Firmware Updates Information 30.01.2013

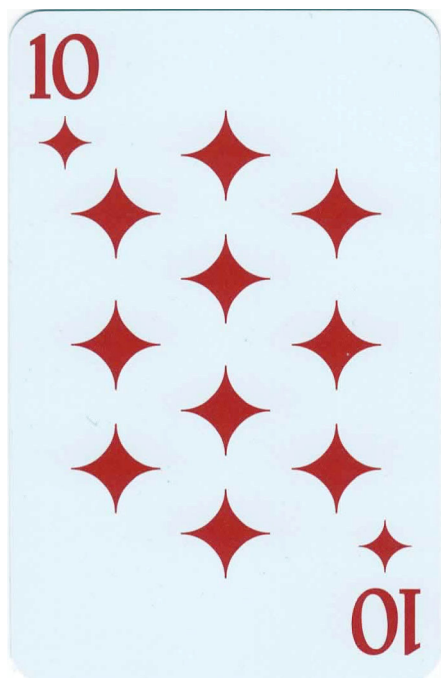
- Corrected problem with club recognition for Japan Nintendo Cards:

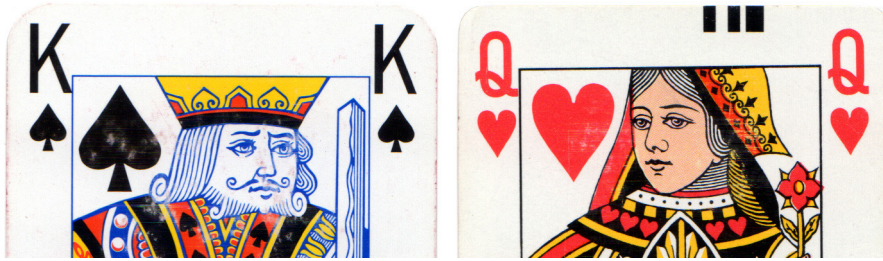
- Improved algorithm for cards with outside frame
- Changed recognition algorithm for cards when card index touches inside frame

- Added recognition of cards where outside frame touches the suit symbol (French Ecole de Bridge cards)

- Added recognition of cards where something touches the suit symbol from bottom (French Societe Generale cards)

- Changed algorithm to recognize diamond suit to make it more robust.
